Amendments to the Drawings:

Remarks/Arguments

Fig. 5

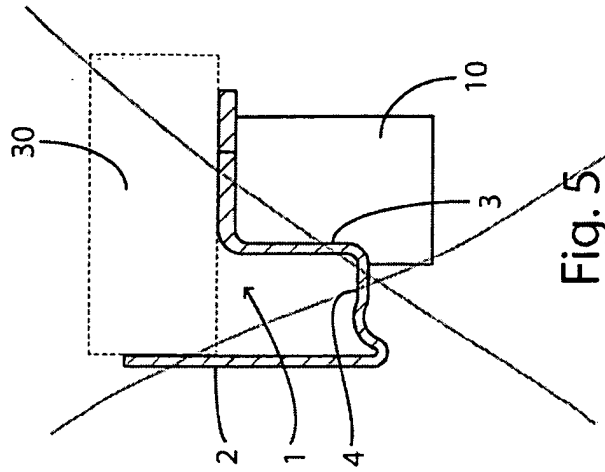
The attached sheet of drawings includes changes to the sheet including Figs. 4-5. In particular, Fig. 5 has been deleted.

Fig. 5 deleted

As noted, the claims were amended to recite the base inferentially and the figures were amended to remove any illustration of the base. Accordingly, it is believed that the objection regarding the base has been overcome.
